PROPOSED WAREHOUSE

PROPOSED LOT 505 on SP316171 301 Coastlink Court, Stapylton

LANDSCAPE PLANS APPROVED

Application No.: OPW/2025/1127

Scale:		1:400 at A3
Designed:	JLS	
Checked:	JLS	
Approved:	MG	
Date:	17.09.25	
Drawing No:	L-PRI-PP06	Rev. No: 3

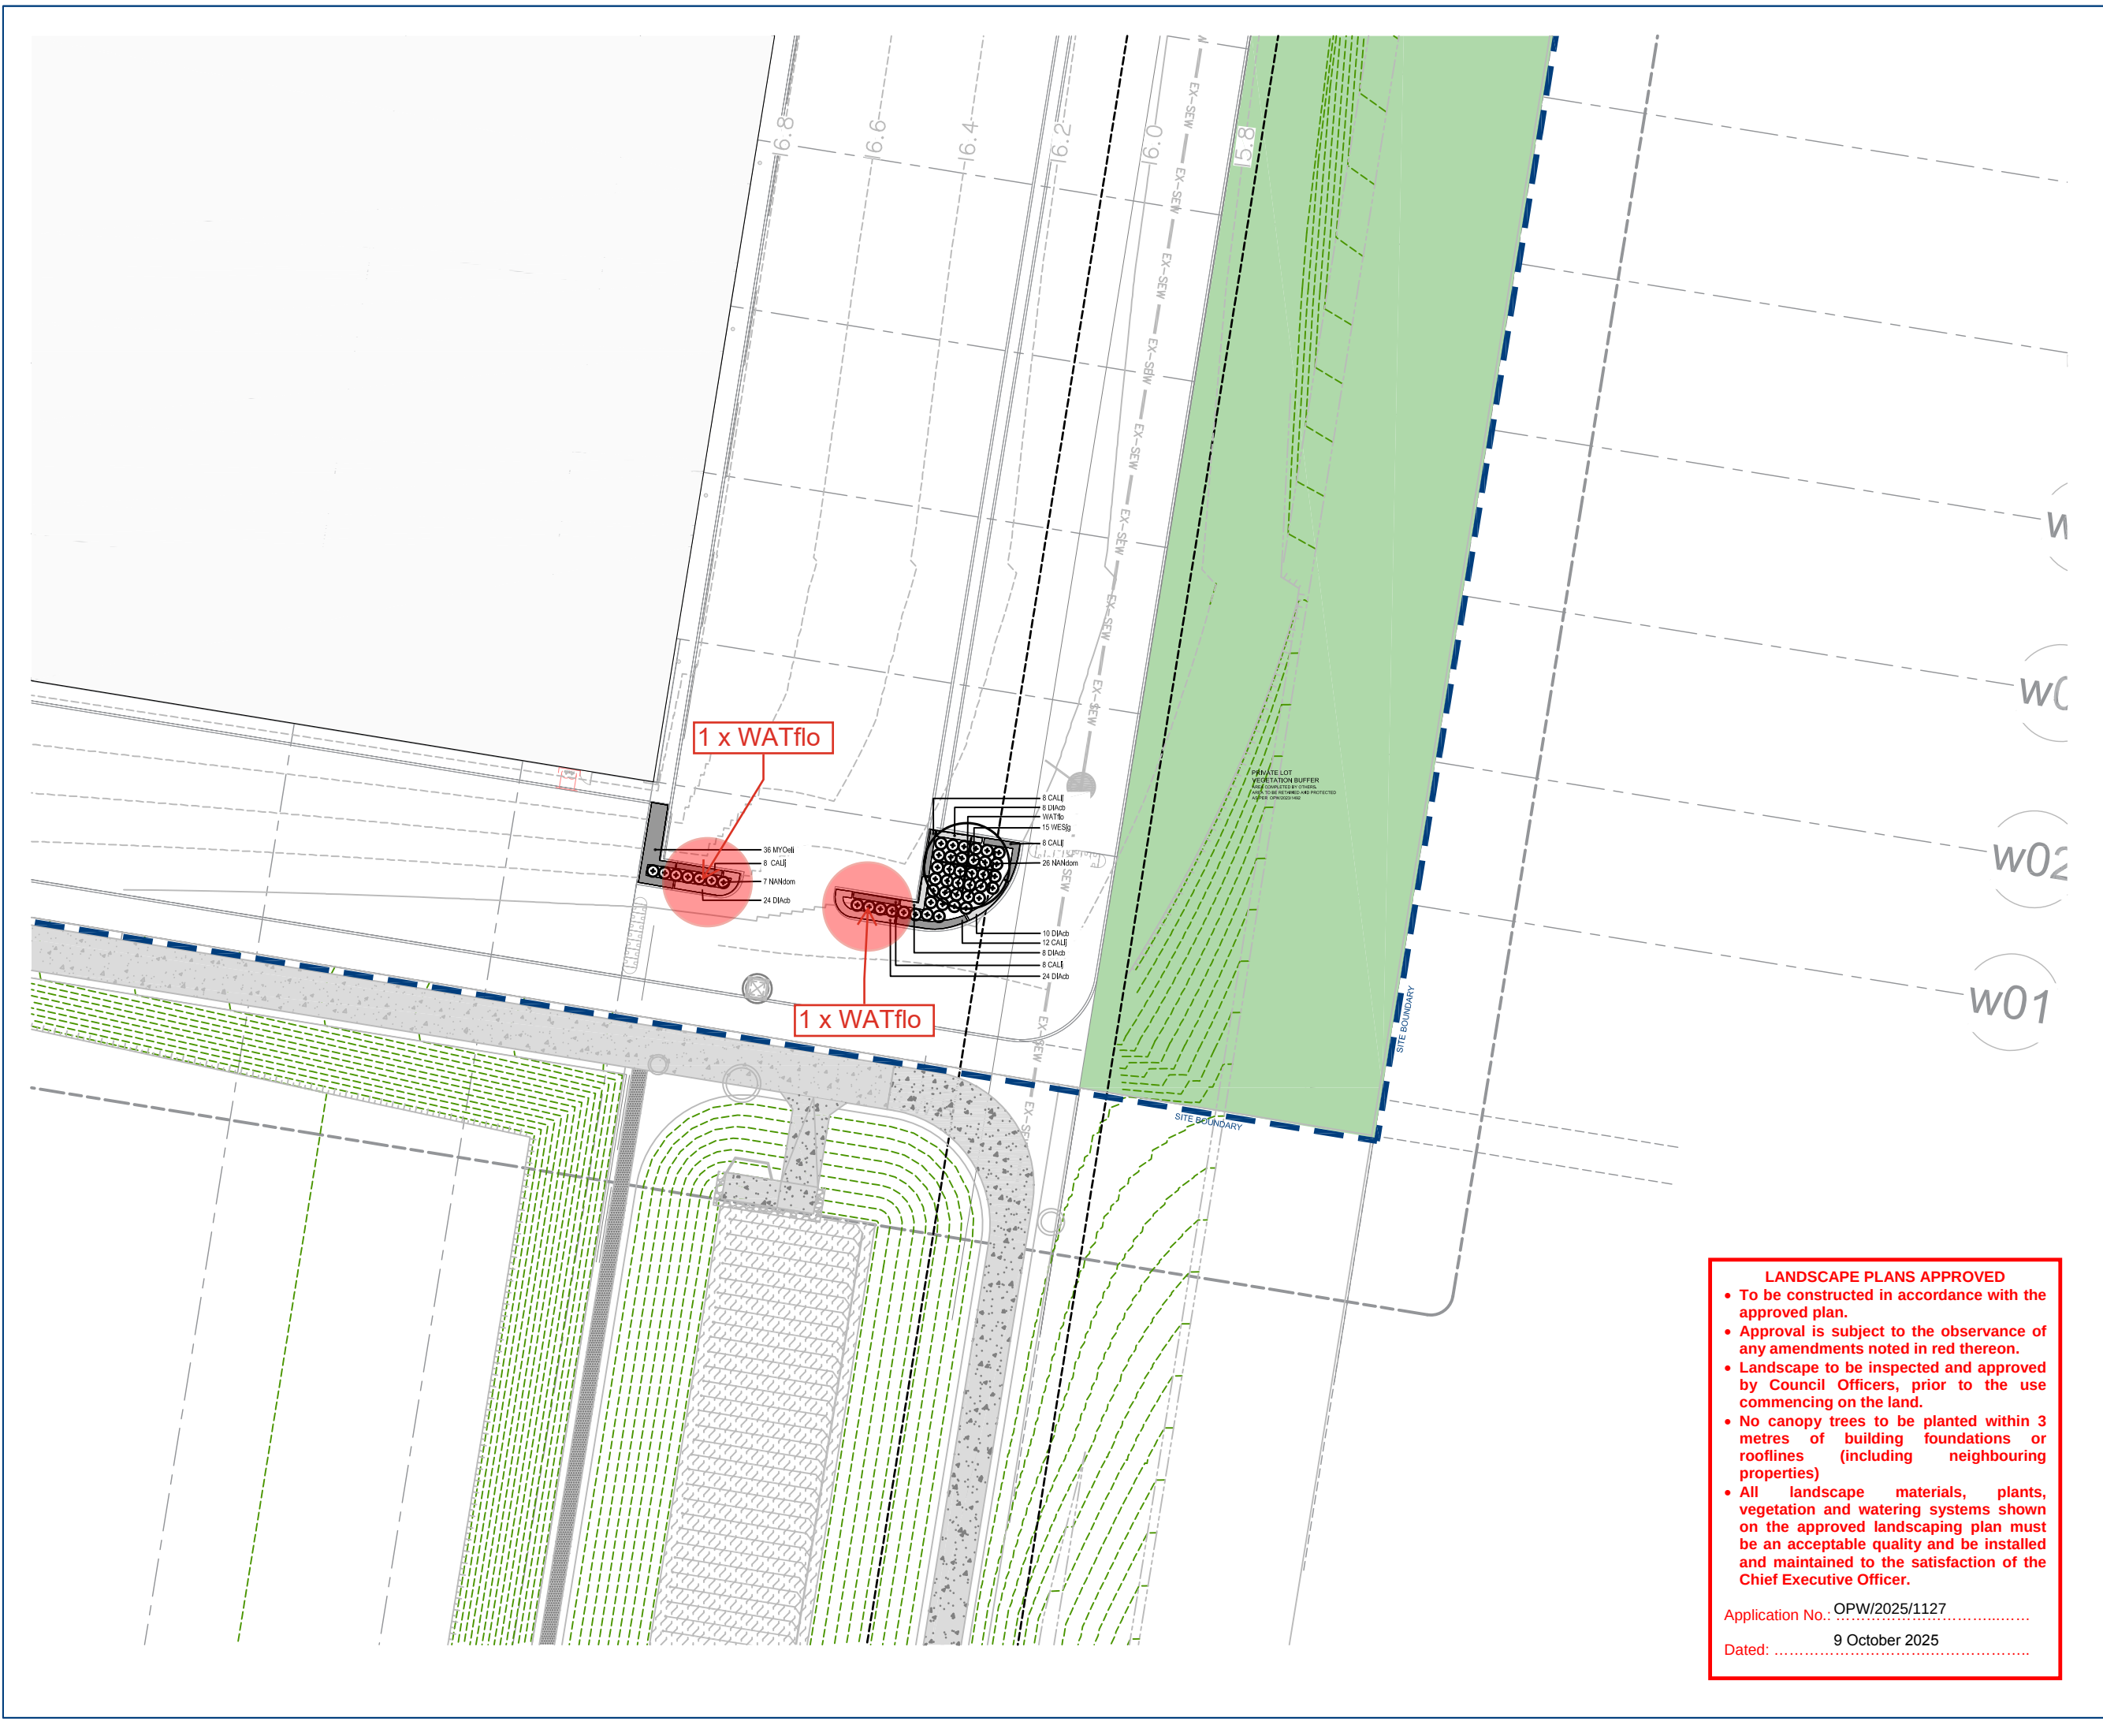
Note:
Where street trees are removed, street trees must be installed within the public road reserve fronting the subject site on Coastlink Court generally in accordance with standard drawings 05-102 and 05-103 within SC6.12.10 City Plan Policy - Land development guidelines.
